**Addendum to the Z-Area  
Radiological Performance Assessment**

**WSRC-RP-98-00156  
Revision 0**

**ADDENDUM TO THE  
RADIOLOGICAL PERFORMANCE ASSESSMENT  
FOR THE Z-AREA SALTSTONE DISPOSAL FACILITY  
AT THE SAVANNAH RIVER SITE**

**Additional Information Supplied to the  
DOE Performance Assessment Peer Review Panel and  
DOE Headquarters in Support of Review, 1993-1997**

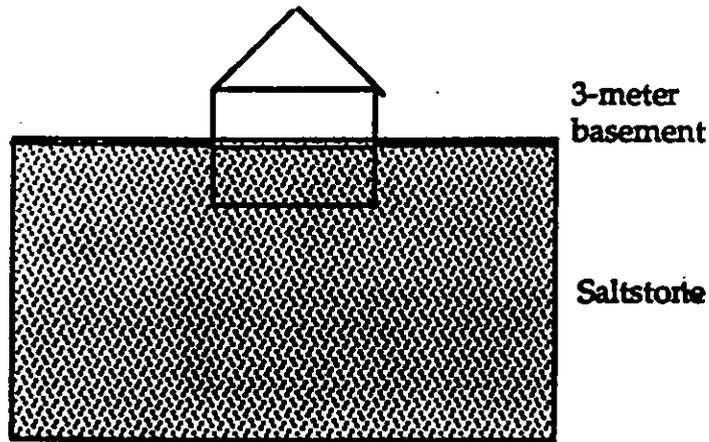
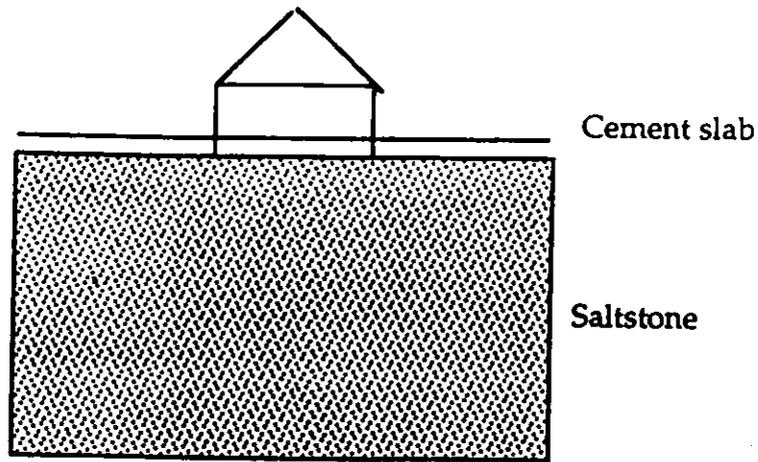
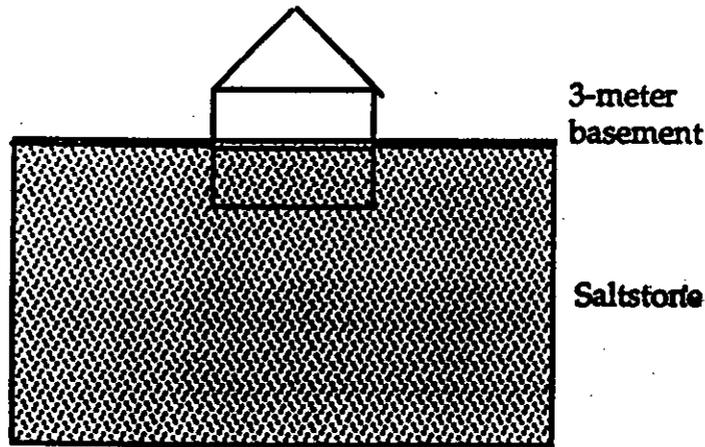
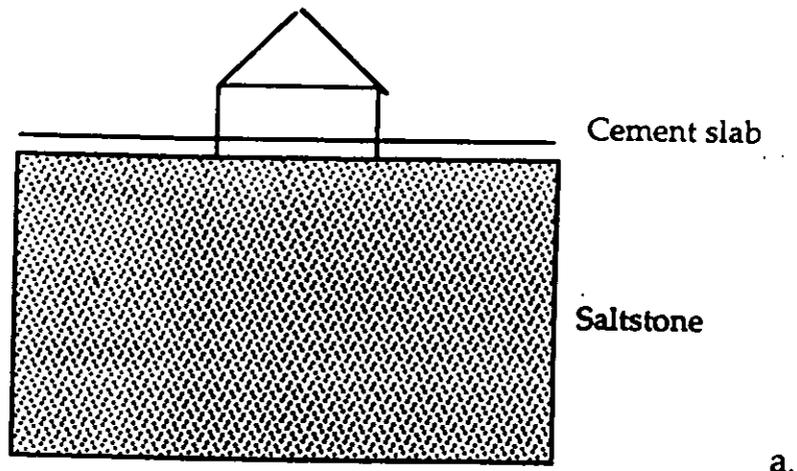
Because the adjusted doses are still relatively close to the 100 mrem/y limit, it would have been useful to do a more realistic analysis of the external radiation doses to resident intruders. For example, it was never really clear what geometry was used to determine the external doses. Specifically, was the basement situated on top of the saltstone units or completed into the degraded units? According to Appendix A,

external exposures were based on radionuclides that are uniformly distributed in a slab of infinite thickness that is made up of soil-equivalent material. A shielding factor of 0.7 is used to reduce exposures because of the protection afforded by floors and walls. Exposures are determined for an individual that is 1 m from the source region. But does that mean an individual living in a basement? Figure 1 depicts two types of basement completions that are possible. The first one (Fig. 1a) has the basement on top of the saltstone, with the barrier gone or degraded. In this case little or no contaminated material has been excavated and mixed with surface soils. In the second case, though, excavated materials are likely to contaminate surface soils. But, as was noted in the text, the saltstone could not support vegetation so clean soils would have to be brought in? Yet would the contaminated materials from the excavation of the foundation be mixed with the imported topsoil? Note that the garden scenario assumes that contaminated soil/saltstone is mixed with uncontaminated topsoil in a ratio of 1:5. Thus, the garden scenario is implicitly tied to some sort of saltstone excavation.

Figure 2. Alternative scenarios of completing houses with concrete slab foundations onto saltstone units with degraded barriers, (a) slab is situated on top of the saltstone and (b) the slab is poured into a shallow foundation penetrating the saltstone.

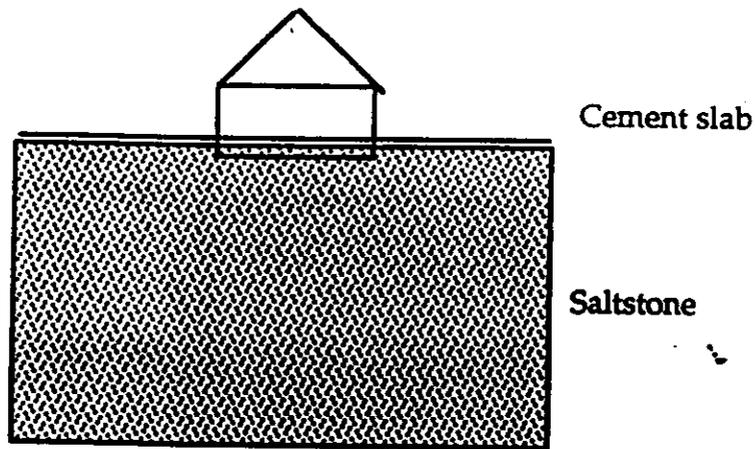
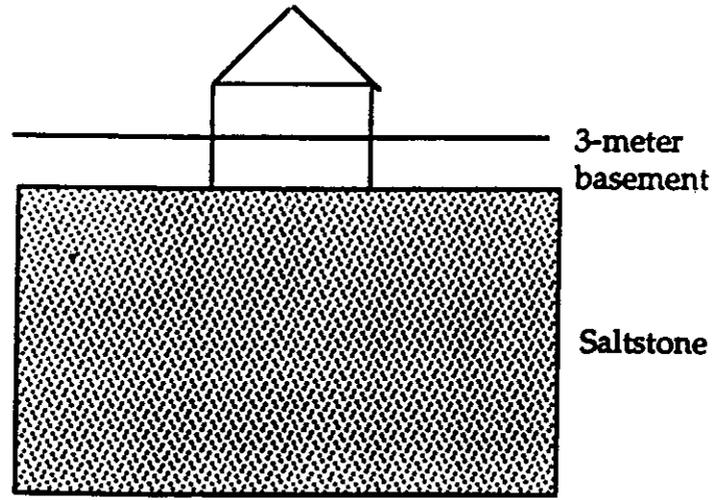
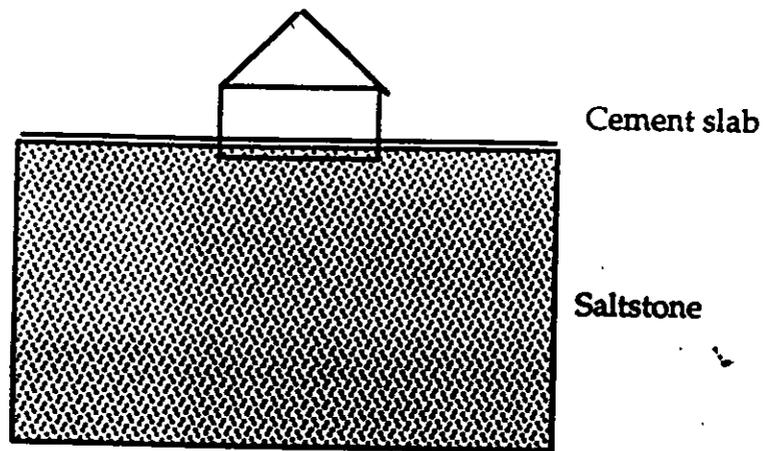
Figure 2 depicts the placement of houses with concrete slabs onto the saltstone units. It would appear that these types of houses come closer to matching the source-receptor geometry that is being assessed in the PA. However, a lot less soil/saltstone is removed with the excavation associated with a concrete slab. For example, the average house in the U.S. has about 150 m<sup>2</sup> of floor space, and thus with a 3 m basement, 450 m<sup>3</sup> of material would be excavated. By comparison, the excavation for a house on a slab might only remove 0.3 m of soil, producing only a tenth as much material. This means that there would be substantially less material to contaminate a home garden or imported topsoil. As a matter of fact, the most prevalent foundations in the South are concrete slabs and perimeter foundations (crawl space). Only about 20% of the houses have full or partial basements (see Fig. 3). Thus, a more realistic assessment would focus on the external radiation exposures for individuals living in houses that are more representative of those build in the South.
